PRODUCT CHANGE NOTIFICATION

Bourns® Model SRN1060 Series Semi-shielded Power Inductors

Change to Inductor Core Design

New Inductor Core Design

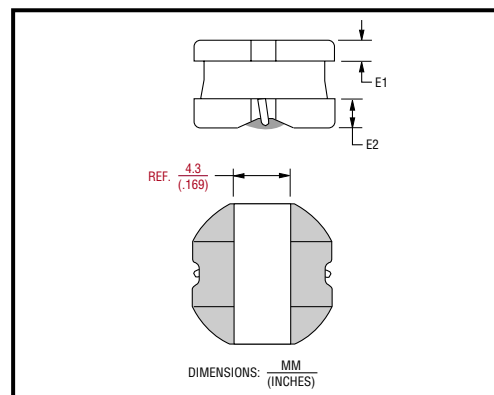
Riverside, California – September 14, 2021 – Effective March 12, 2022, Bourns will change the inductor core design for the [Model SRN1060 Series Semi-shielded Power Inductors](#). The modified inductor core will have a slightly thicker top, bottom flanges and a wider terminal separation distance. These modifications will improve the core's strength.

Larger E1, E2 dimension and wider terminal separation distance

Existing Recommended Layout

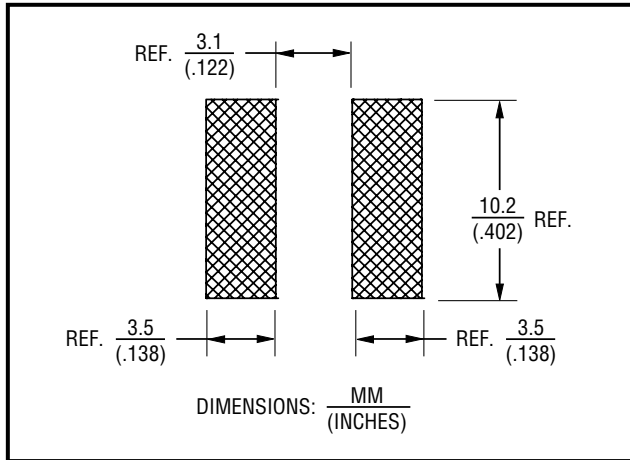
As a result of the core modification, the recommended layout will change.
